**PLANNING COMMISSION
STAFF REPORT**

AGENDA ITEM: Planning File No. 238-18-MAJ: A public hearing of the Major Site Plan application for the proposed Rainbow Court East Building mixed-use project

LOCATION: 310 East Main Street / Lots 3-5, Block 9, Frisco Townsite

West Façade of Addition: May 2, 2019

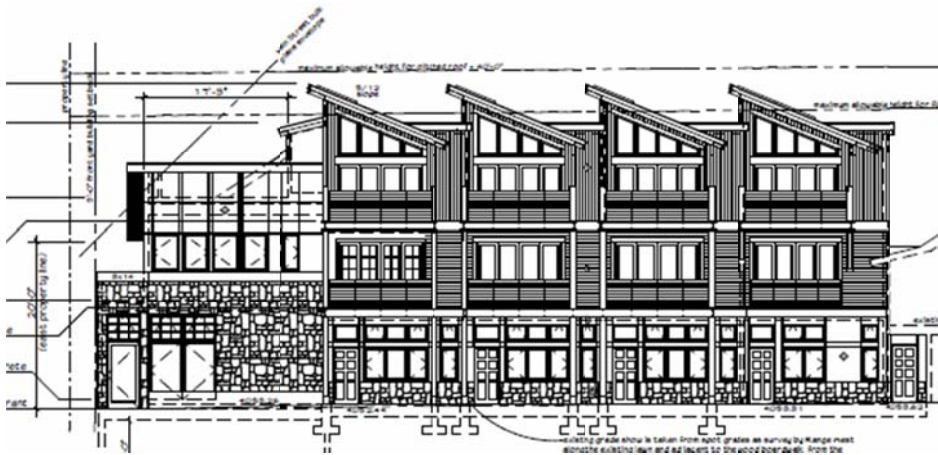
The proposed building contains four (4) residential units. As can be seen in the below pictures, the applicant has made changes to the west façade of the new addition so that the four units are not identical. Changes made include variation in windows and changes in colors and materials. Further design changes, including additional doors on the ground floor, have been made since the March 21, 2019 Planning Commission meeting to accommodate the addition of retail spaces proposed on the ground level of the east building.
